Gad's Hill Place Cupola Repairs.
Notes taken from
meeting @ Fareham Joinery
22/5/2024.
1 of 14 pages.

Project GAD'S HILL SCHOOL, HIGHAM
GAD'S HILL PLACE REPAIRS

Title CUPOLA REPAIRS
EXISTING SECTION AND SIDE ELEVATION

3) Base of cupola post by roof HRFX04.

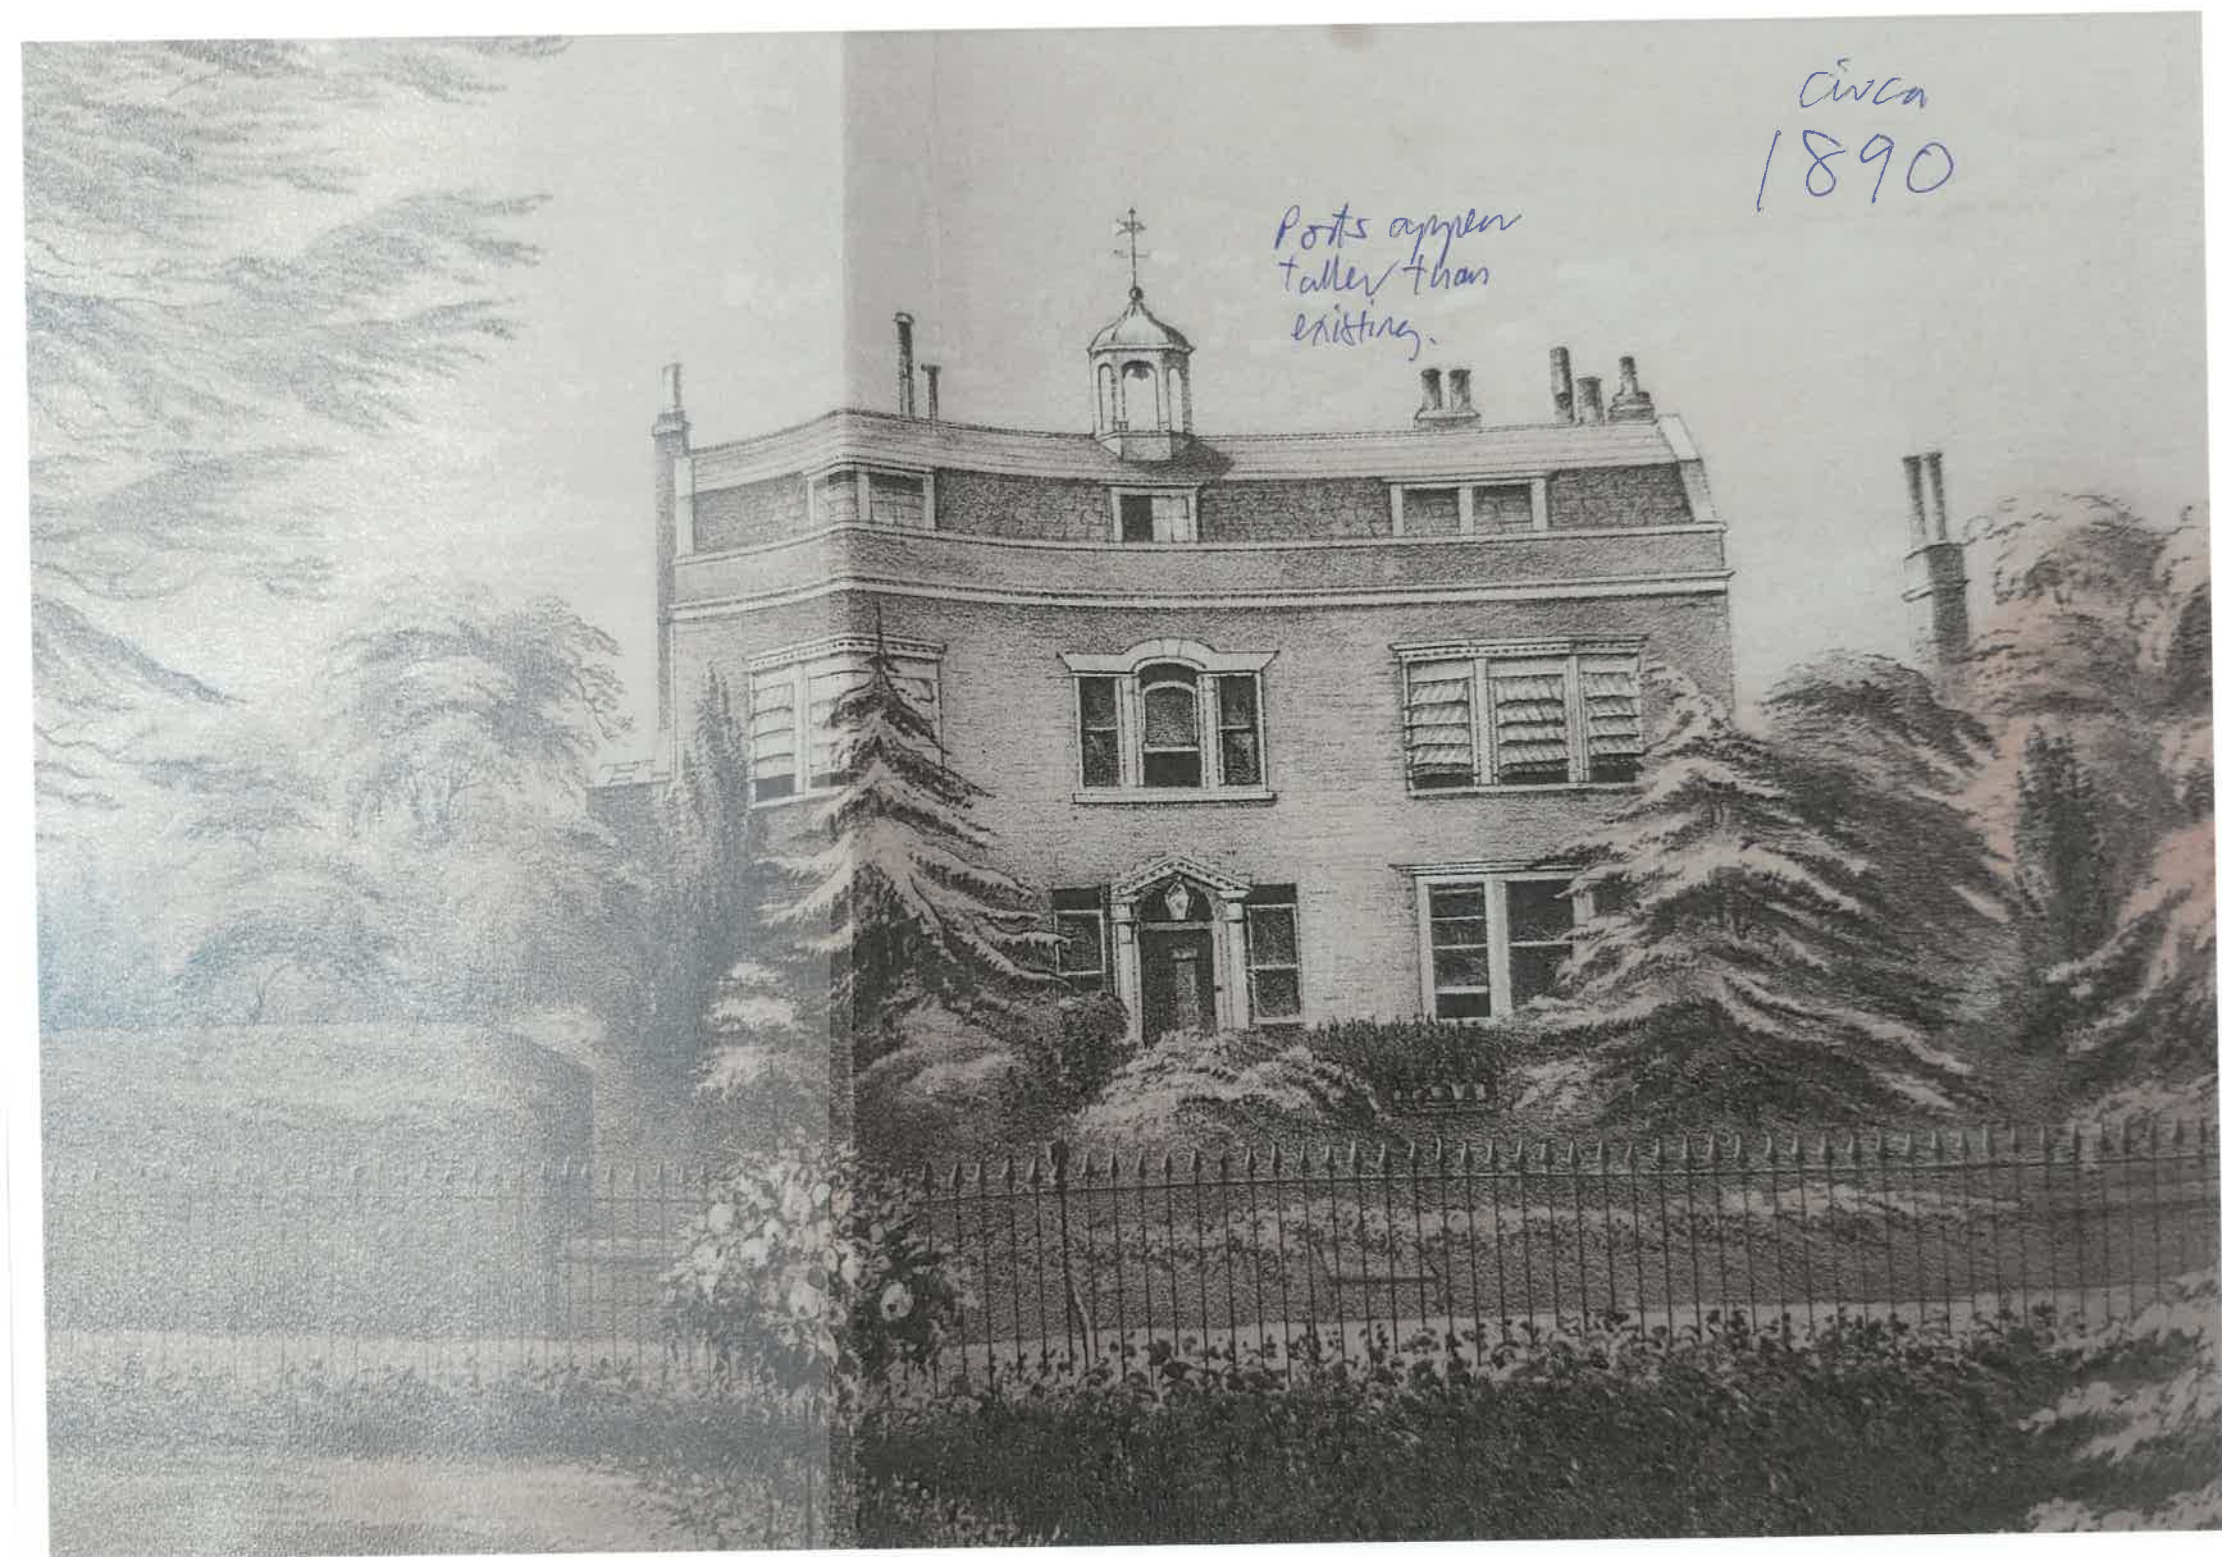
Post appears shorter than on historic drawings or photos.

Some of the posts are rotten, paintwork has cracked allowing water ingress. Cupola has twisted.

Post is rotten and needs to be replaced.

Propose to replicate historic base flashing detail to protect exposed base of the posts.

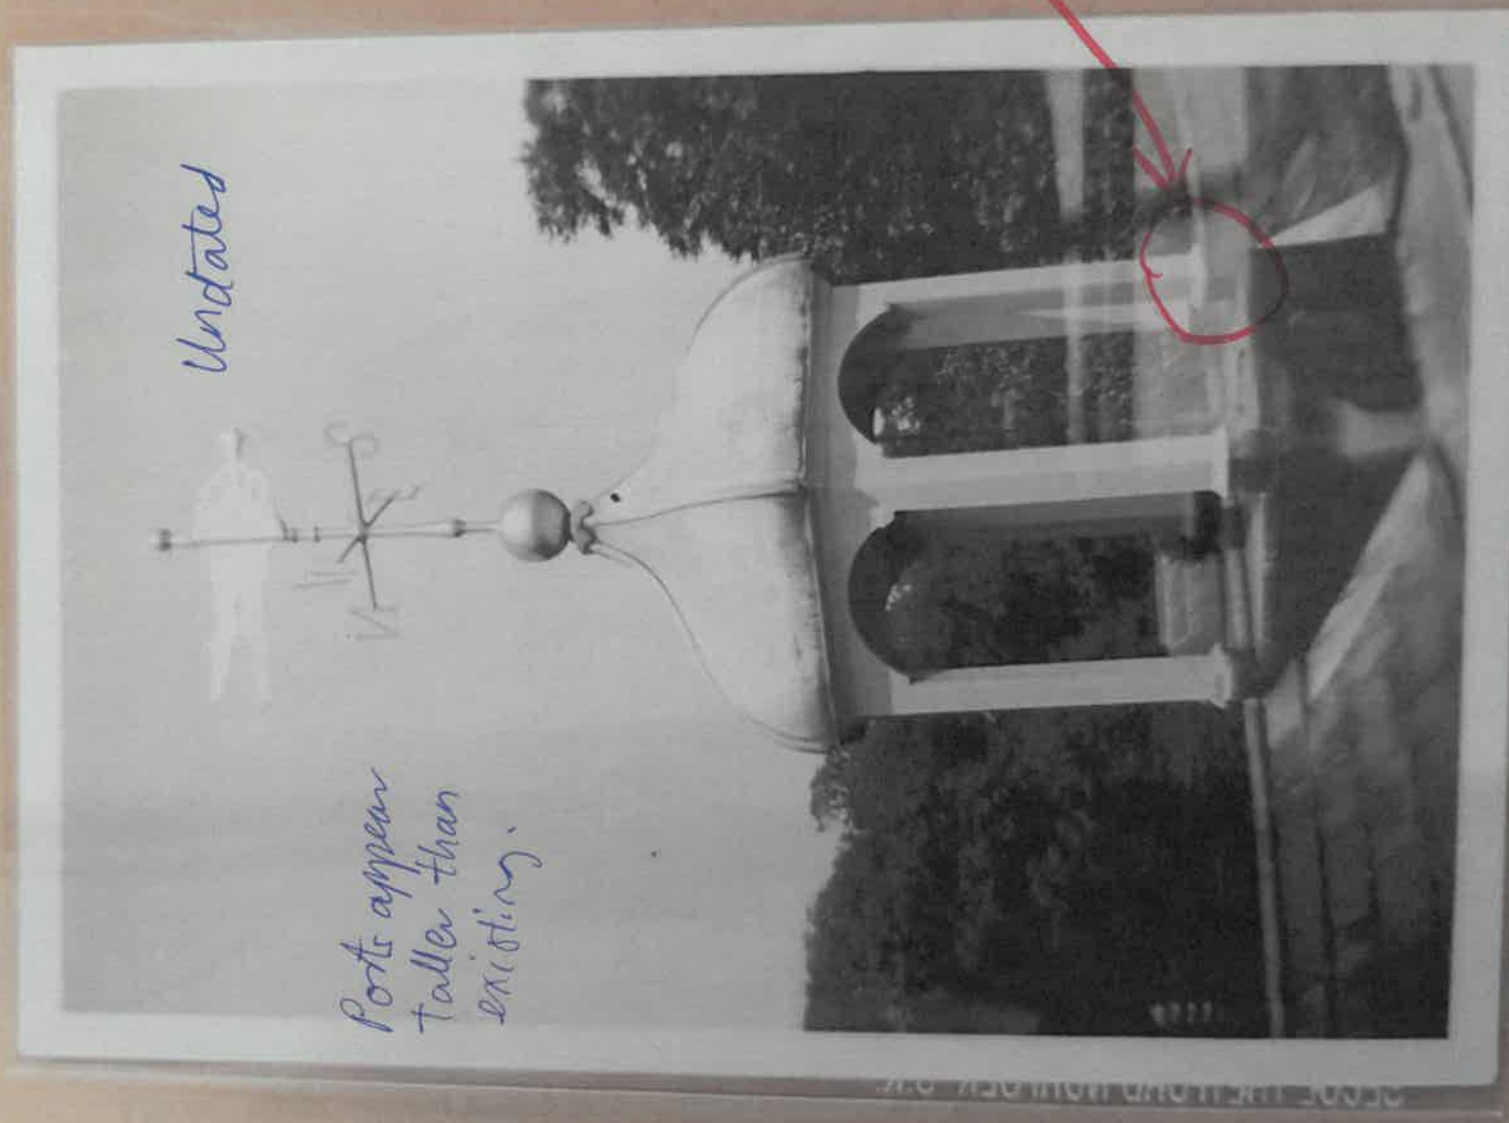
Roofs appear
taller than
existing.

Ports appear
taller than
existing.

post.
proposed timber
flashing
cover detail.
lead
flashing.
